**State Significant Development Application
SSD-10321
Residential Development at 89 John Whiteway Drive GOSFORD**

This document serves as our second letter of **objection** to this development the first being our letter dated 19 May 2020.

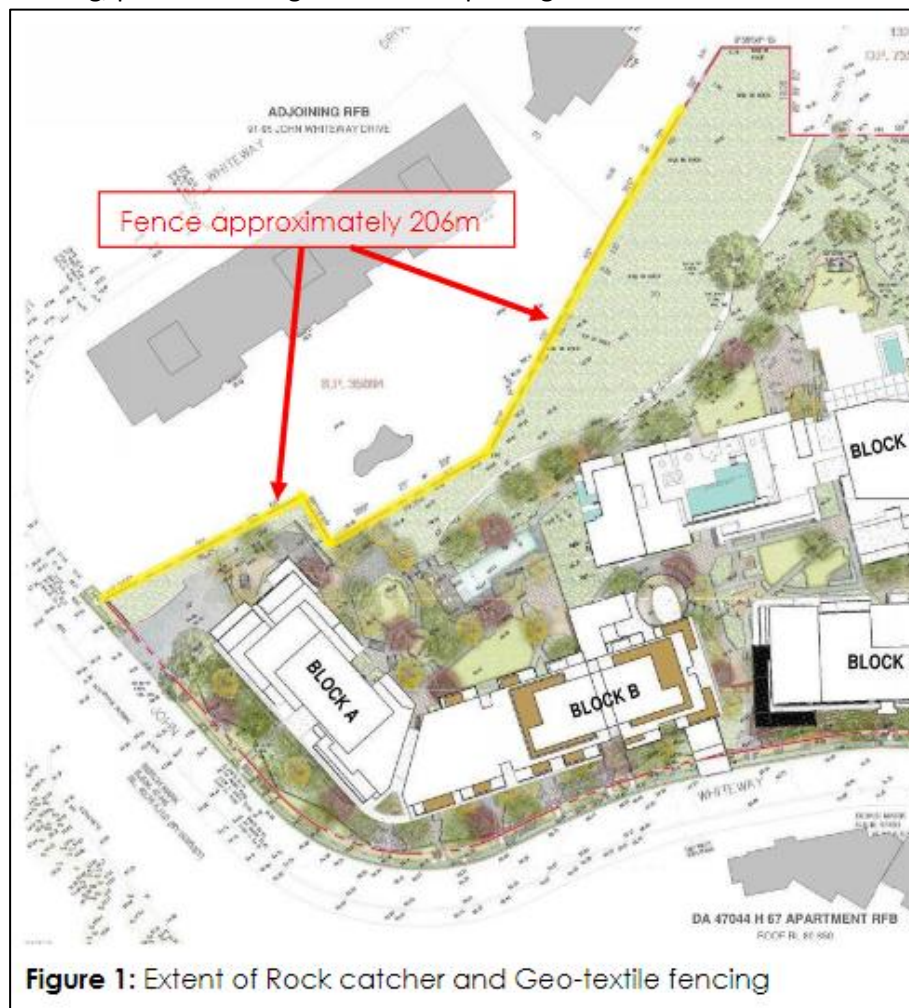
We **object** to the developer's response regarding the current oversaturated conditions and that:

"action needs to be initiated now by TfNSW and Central Coast Council to increase capacity and introduce measures to manage travel demand";

It is clear that they are shifting the problem of the proposed developments' increased traffic volumes onto Central Coast Council and TfNSW to sort out. This proposed development, with its potential for increased traffic volumes, should not be approved until such time as the CBD network can accommodate the extra volume.
